# Access Compliance Report

## Public Rights-of-Way

### (Curb Ramps)

Intersection ID: N/A	Main Street: MORABLIN_DR	Cross Street: DURANT_BV	Location: NW
ADA ID: 64CFBF09565F	Ramp Type: PerpDiag	Initial Pass/Fail: Fail	Overall Compliance: No
Severity Score: 46.25			
Codes/Mitigation Info/Possible Solution		Field Measurements/Component Compliance

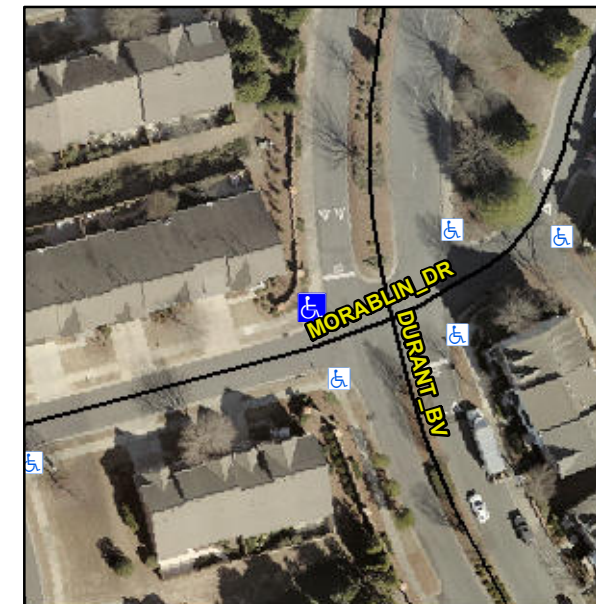
**Not Found, R304.5.1, R304.2.2, R304.5.3**

Compliance	Description	Data	Compliance	Description	Data
N/A	Ramp Length (in)	47.0	No	Ramp Slope (%)	8.6
No	Ramp Width (in)	42.0	No	Ramp XSlope (%)	13.3
N/A	Flare Type LT	N/A	N/A	Flare Type RT	N/A
N/A	Flare Slope LT (%)	N/A	N/A	Flare Slope RT (%)	N/A
N/A	Flare Traversable LT?	N/A	N/A	Flare Traversable RT?	N/A
N/A	Landing Length (in)	N/A	N/A	DWS Provided?	N/A
N/A	Landing Width (in)	N/A	N/A	DWS Contrast?	N/A
N/A	Landing Slope (%)	N/A	N/A	DWS Length (in)	N/A
N/A	Landing X Slope (%)	N/A	N/A	DWS Full Width?	N/A
N/A	Landing Curb? (Y/N)	N/A	N/A	DWS Offset (in)	N/A
N/A	Shared Landing?	N/A			
N/A	Gutter Ponding?	N/A	N/A	Gutter Slope (%)	N/A
N/A	Gutter Lip Ht (in)	N/A	N/A	Gutter X Slope (%)	N/A
N/A	Painted X Walk1?	No	N/A	Painted X Walk2?	No
	X Walk 1 Direction	To S		X Walk 2 Direction	To NE
N/A	X Walk 1 Width (in)	N/A	N/A	X Walk 2 Width (in)	N/A
	X Walk 1 Slope (%)	4.6		X Walk 2 Slope (%)	7.9
	X Walk 1 X Slope (%)	5.3		X Walk 2 X Slope (%)	6.0

**Remove & Replace Curb Ramp With Two New Directional Ramps or Equivalent.**
